**AMENDMENT UNDER 37 C.F.R. § 1.116**  
**U.S. Application No. 08/898,853**

This Amendment is submitted in response to the Office Action of February 23, 1999, in the above-referenced application.

FIG.2

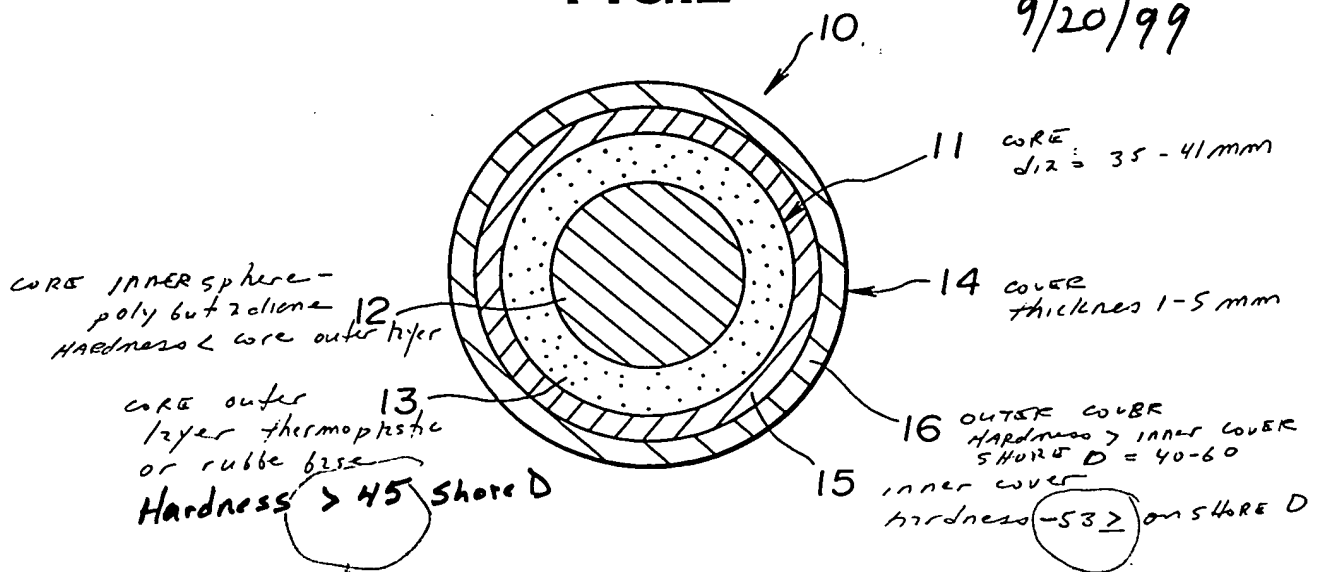
Regarding the proposed drawing amendments filed on October 28, 1998, the Examiner contends that every feature of the claimed invention are not illustrated. The

Examiner makes specific reference to claim 5 and the surrounding layer hardness of D 45 as not being indicated in the proposed drawing amendments. In response, Applicant submits herewith a further revision to Figure 2 for the Examiner's consideration. The proposed changes are shown in red ink. As can be seen, the surrounding layer 13 has been indicated as having a Shore D hardness of at least 45 degrees. Applicant respectfully submits that this should obviate the proposed drawing objections and withdrawal of the objection is respectfully requested.

Not 50  
7 45  
excludes  
45

Not  
Approved  
*SDM*  
9/20/99

claim says  
of least 45  
Not greater than 45
